FRAMATOME COGEMA FUELS

Reference: Stewart Bailey to T. A. Coleman, Request For Additional Information –
Framatome Topical Report BAW-10133P, Addendum 1, "Mark-C Fuel Assembly
LOCA-Seismic Analysis," Revision 1 (TAC No. M99906), January 4, 2000

RESPONSES TO NUCLEAR REGULATORY COMMISSION QUESTIONS ON
BAW-10133P, REVISION 1, ADDENDUM 1

**Figure Q11.2 Fluid Model of the
3 x 3 Assembly Array**

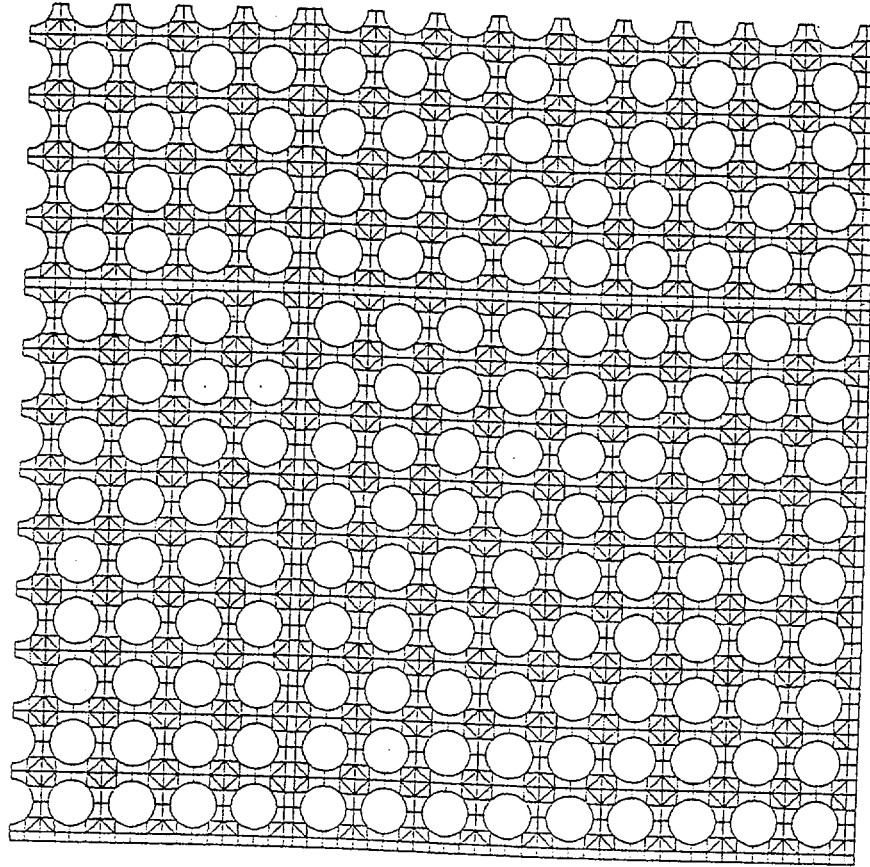
11. Page 2-6 gives non-dimensional values for the assembly added mass and the coupling with baffles for a 17X17 assembly, and states the values are "derived from a fluid model." While these values are similar to those reported in Reference 10 of Addendum 1, no detail of the fluid model was given. Please provide details of the fluid model.

The fluid model and its description are provided in Reference 1A of this document. Figure Q11.1 represents the schematic of this model, which comprises of a 3x3 array of 9x9 rod array assemblies. Figure Q11.2 represents the fluid mesh, reduced to the lower right quarter from symmetries with respect to the X and Y axes. As reported in Reference 10 of Addendum 1, the rod diameter – [b,c,d] and pitch [b,c,d] correspond to the 17x17 design. Gaps of [b,c,d] between assemblies or with the core baffles are included (average in-core value).
